NEW SUMMARY OF SUBMISSIONS
Structure Plan for Mundijong Precincts E1 & E2
Advertising Period: 21 December 2023 to 9 February 2024

<table><tr> <th data-bbox="528 842 608 978">No.</th> <th data-bbox="608 842 715 978">Page</th> <th data-bbox="715 842 1421 978">Section</th> <th data-bbox="1421 842 1792 978">Rev 1 - DWER Comments EP22-016(01)-003C JB (Version D)</th> </tr></table>

<table><tr> <td colspan="2" data-bbox="507 1079 1635 1203"> <p>Please provide the following items to address the comments in the below table: Mundijong Precincts E1 and E2 Local Structure Plan – Prepared by Rowe Group, Ref 9417, Version 2, Date 06/11/2023</p> </td> </tr></table>

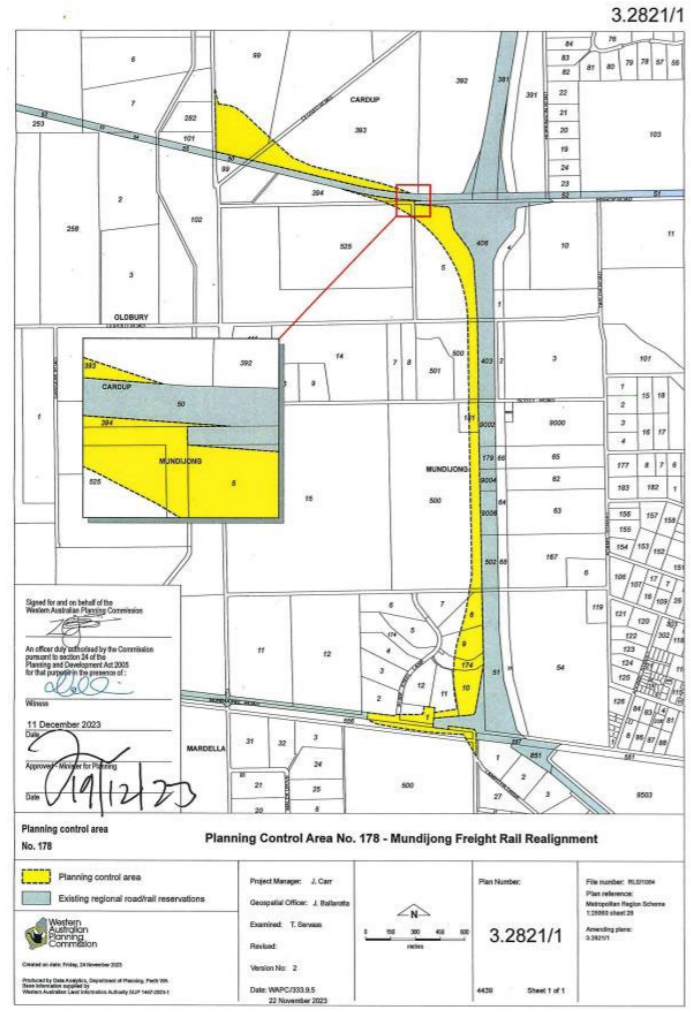
1.2	<p>Update Figure 11 to remove the 'site access' arrow on Scott Road abutting the future Tonkin Highway and indicate the 'site access' arrow similar to that for Sparkman Road. Refer to marked up Figure 11 below:</p>

Submitter	No	Submitter Comments	Officer Comment	Applicant Comment
		<div data-bbox="1092 346 1469 865" data-label="Image"> </div> <p data-bbox="1092 884 1469 913">Justification for Information</p> <p data-bbox="1092 932 1626 1150">Figure 11 infers the northern site access from Scott Road connects onto the future Tonkin Highway. The road designs for Tonkin Highway Extension project shows Scott Road to a cul-de-sac on both the eastern and western side of the future Tonkin Highway.</p>		
		Transport Impact Assessment October 2023 – Prepared by Donald Veal Consultants Pty Ltd, Ref Mundijong LSP TIA, Version 1, Date 19/10/2023

Attachment 1: Planning Control Area 178 - Mundijong Freight Rail Realignment Plan No. 3.2821/1

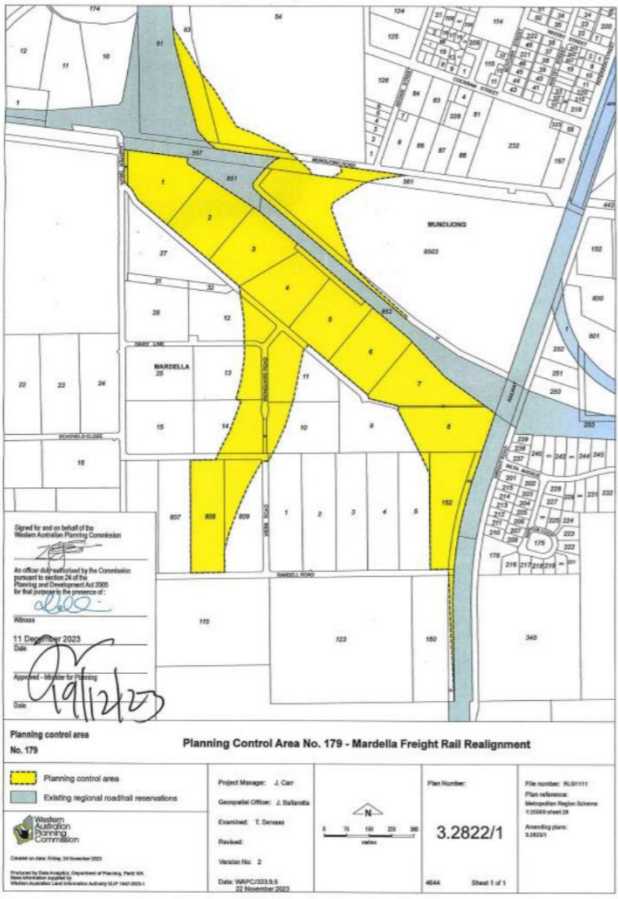
<p>Noise Management Plan September 2023 – Prepared by Herring Storer Acoustics, Ref 31580-2-22095, Version 2, Date 17/10/2023</p>		
		<p>3.0</p> <p>Amend the document to assessed rail noise and reflect the Mundijong Freight Rail</p>

Submitter	No	Submitter Comments	Officer Comment	Applicant Comment
		<p>Realignment corridor within Planning Control Area 178 - Mundijong Freight Rail Realignment (PCA 178) and PCA 179 and review the rail noise recommendations.</p> <p><u>Justification for Information</u></p> <p>The document has not assessed rail noise and assumes no realignment of the freight rail line. The document has not considered the preferred corridor alignment decision in November 2022 for the Mundijong Freight Rail Realignment within PCA 178 and PCA 179. The PCA 178 Plan No. 3.2821/1 (attached) and PCA 179 Plan No. 3.2822/1 (attached) shows the freight rail to be realigned on the western side of the future Tonkin Highway and west of the Structure Plan.</p>		
		<p>3.1</p>		
		<p>Provide an updated document and modelling addressing the following:</p> <ul style="list-style-type: none"> • Road and rail traffic parameters, noise predictions and treatment recommendations must be provided for 2044 in order to comply with the SPP 5.4 requirements for a 20-year planning horizon. • The specific type of chip seal for Mundijong Road (i.e. 5 mm, 10 mm or 14 mm) needs to be stated and used as an input for the noise modelling. "Chip seal" is not adequate. • Daytime noise predictions were provided, yet the on-site noise measurements presented indicated that night-time noise was higher. This needs to be discussed in relation to how both the SPP 5.4 daytime and night-time noise targets can be met, with night-time noise predictions and associated treatment recommendations presented in the document. • Update last paragraph of section 5. Traffic Noise Assessment of the document to specify the noise barrier is required to be 2.4m high and the height is taken from the future sand pad levels of the residential lots abutting the noise barrier. <p><u>Justification for Information</u></p> <p>The document provided does not comply with State Planning Policy 5.4 Road and Rail Noise (SPP 5.4) and is uncertain.</p>
